UNITED STATES PATENT AND TRADEMARK OFFICE

APPLICATION NO.	FILING DATE	FIRST NAMED INVENTOR	ATTORNEY DOCKET NO.	CONFIRMATION NO.
09/879,966	06/14/2001	Yoshihiko Sano	NPR-074	4190

Office Action Summary

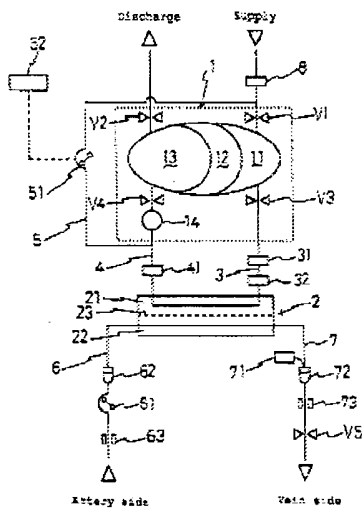
2. Claims 1 and 4 are rejected under 35 U.S.C. 102(e) as being anticipated by Nikaido et al (U.S. Patent No. 6,274,034).

Nikaido et al teaches an apparatus for preparing solution including a chamber divided by a movable partition 12 into first 11 and second 13 compartments, a first (“Supply”) and second 5

supply line connected to the first compartment 11, a solution line 4 connecting the first compartment 11 and the second compartment 13, a solution tank 21 and transporting pump 14 in the solution line 4, and a transporting line “Discharge” connected to the second compartment 13.

FIG. 1

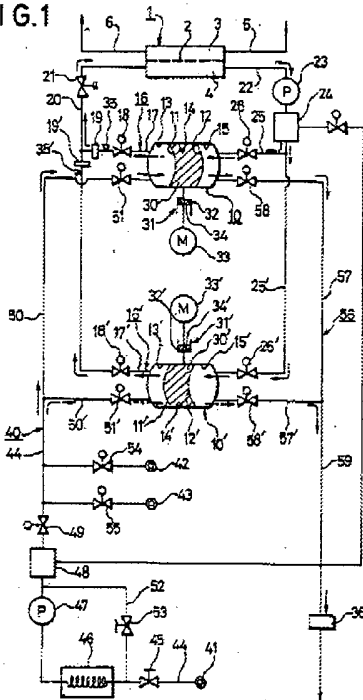
3. Claims 1, 4, 5, and 12 are rejected under 35 U.S.C. 102(b) as being anticipated by Era et al (U.S. Patent No. 4,935,125).

Era et al teaches an apparatus for preparing solution including a chamber **10** divided by a movable partition **30** into first **13** and second **15** compartments, a first **50** and second **50'**

supply line connected to the first compartment **13**, a solution line **20,22** connecting the first compartment **13** and the second compartment **15**, a solution tank **4** and transporting pump **23** in the solution line **22**, and a transporting line **57** connected to the second compartment **13**. The apparatus of Era et al further includes a second chamber **10'**, divided by a movable partition **30'** into first **13'** and second **15'** compartments, and wherein the second chamber **10'** is connected to the supply line **50'**, the solution line **25'**, and the transporting line **57'**.
